Docket Number:	07-AFC-06C
Project Title:	Carlsbad Energy Center - Compliance
TN #:	203058
Document Title:	Responses to Power of Vision Data Request Set 1 (Nos. 1-5)
Description:	N/A
Filer:	Dee Hutchinson
Organization:	Locke Lord LLP / J Mckinsey
Submitter Role:	Applicant Representative
Submission Date:	9/12/2014 4:38:26 PM
Docketed Date:	9/12/2014

Re: Petition to Amend the Carlsbad Energy Center Project (07-AFC-06C)
Project Owner's Responses to Power of Vision Data Request Set 1 (Nos. 1 - 5)

Data Responses to POV Set 1 (Responses to Power of Vision Data Requests 1 to 5)

Figure DR POV 4-1
Cross-Section Looking North at the Unit 9 Transformer
and Interstate Highway I-5
Carlsbad Energy Center Project
Carlsbad, California (07-AFC-06C)
Petition to Amend

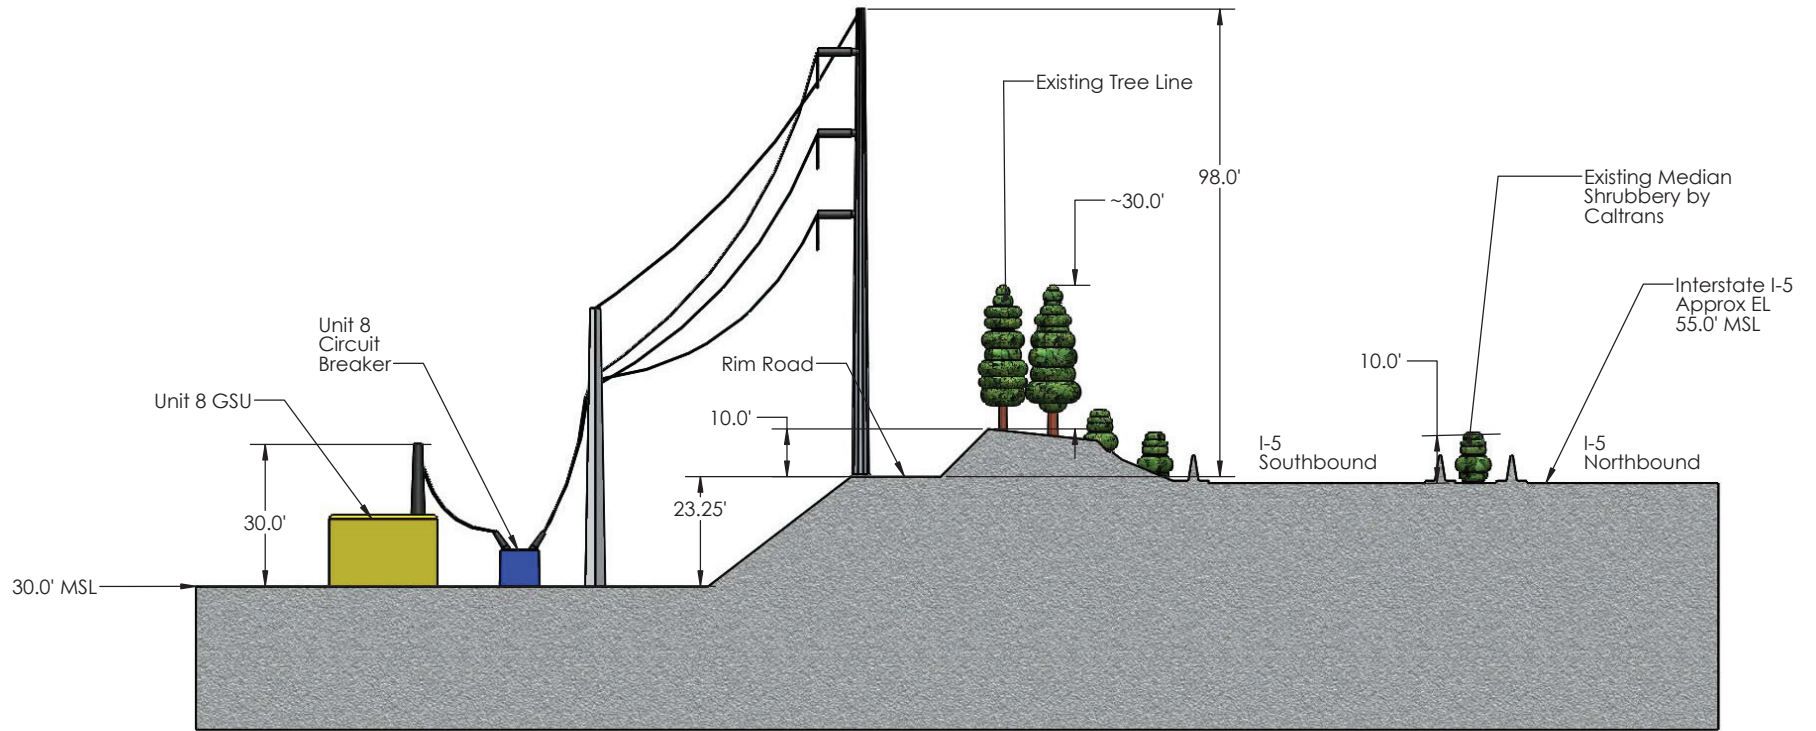
4. Please provide a dimensioned cross-section drawing, looking north, and extending from the west at the units 8 & 9 transformers to the freeway I-5 roadway (See attached "FIG 3.1-1 MODIFIED by POV" section A-A). This cross section should show the transformer, power pole, rim road, visual screening (trees?), and the I-5 freeway.

The cross-section requested has been prepared, and is presented in Figure DR POV 4-1. The cross-section is indicated as cross-section A-A on Figure DR POV 5-1. The transmission line pole for units 8 and 9 will be

located on the west side of the east rim road, approximately 62 feet west of the Encina Power Station property's fence line and approximately 27 feet from the future, expanded Highway I-5 right-of-way.
